SSD 9752870

160 Oxford Street, Paddington

Submission in Objection - Oxford160 Mixed-Use Development

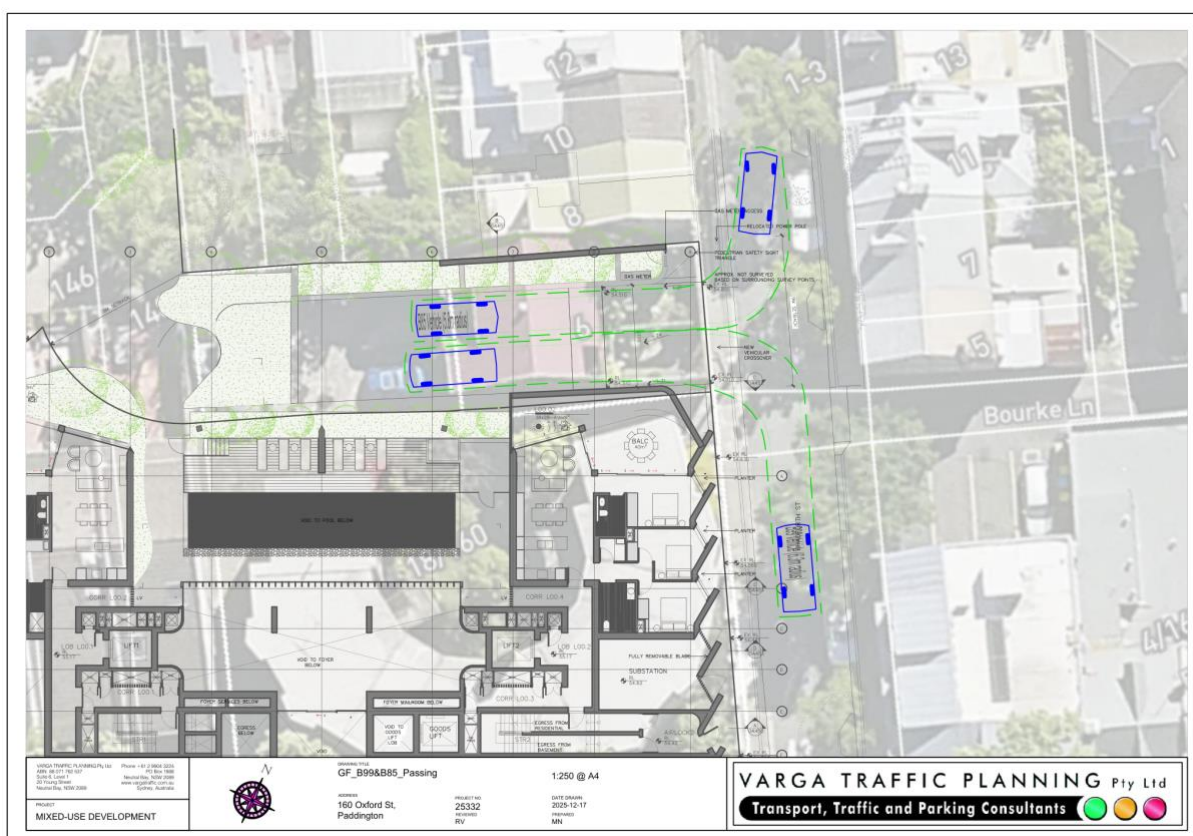
The swept path analysis in the Transport Assessment (Varga, drawing GF_B99&B85_Passing) shows a B85 design vehicle with a 5.8m turning radius turning left from the basement exit onto Shadforth Street. The swept path arc makes contact with the kerbside parking on the eastern side of the street. The Transport Assessment's narrative conclusion that vehicles can manoeuvre without impact is directly contradicted by the consultant's own diagram. The proposed development therefore does not achieve the outcome required by DCP C1(b) - a departure established on the developer's own evidence - this impact has not been adequately assessed in the EIS.

The swept path analysis confirms that vehicle turning movements on exit from the basement make contact with the kerbside parking on Shadforth Street. Additionally, the new vehicle crossover will require no-stopping zones on either side, permanently removing kerbside spaces that existing residents, who have no off-street parking alternatives, currently depend upon. The proposed development therefore does not achieve the outcome required by DCP C1(i), and this impact has not been assessed in the EIS.
